Changes to Rev 1

High Skipper

First Floor:

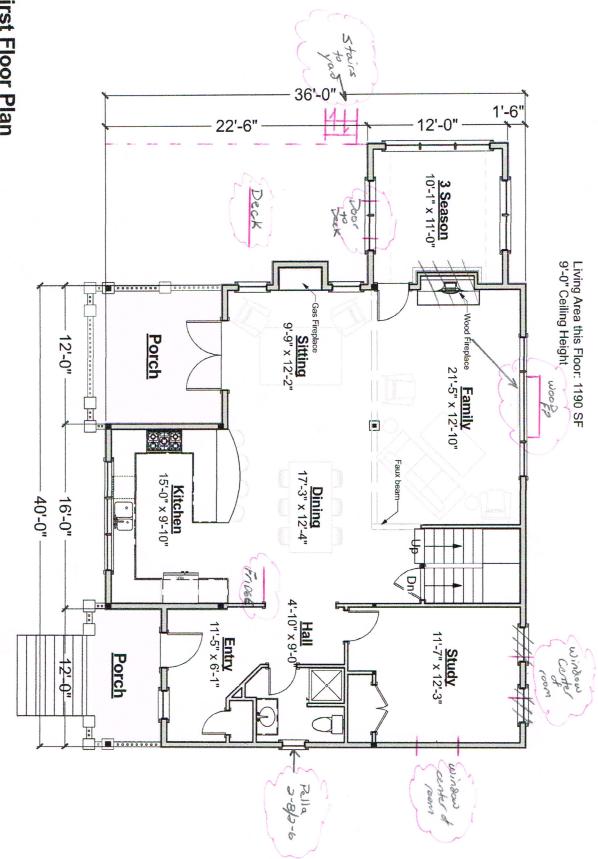
Add Deck from 3 season to front porch, stairs to yard

3 Season Porch: Add 36"W door to deck.

Increase window length.

Cathedral ceiling

Gable end to match house (Overhang).

Family Room: Move fireplace to the center of back wall of family room.

Place window on each side of fireplace, please leave space between FP and

window for exterior trim.

Study: One window on back wall, center of the room.

One window on side wall, center of the room.

Bathroom: Larger window (Pella 2-8/2-6 min)

What is the size of shower?

Kitchen: Put a return wall for fridge.

Second Floor:

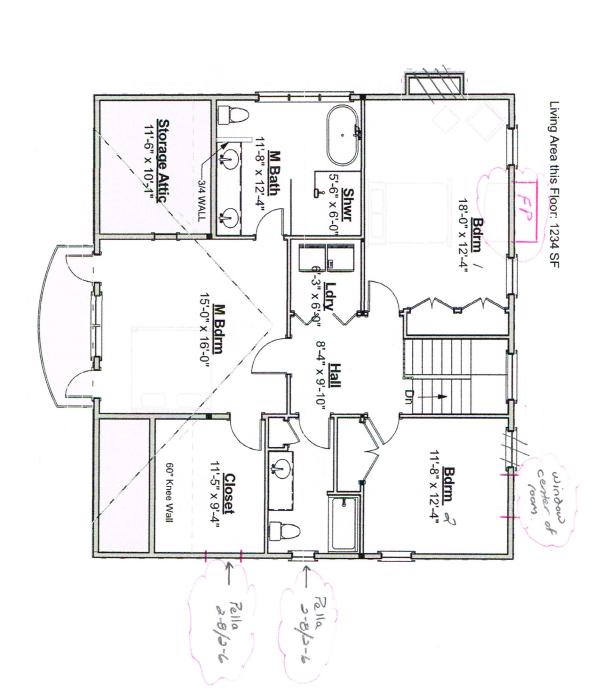
MBR Closet: Add window (Pella 2-8/2-6)

Bedroom #1: Move FP location from side to back wall, centered between windows. Bedroom #2: Back wall window, move to center of the room (Line up with first floor).

Bathroom: Window to be same as MBR closet.
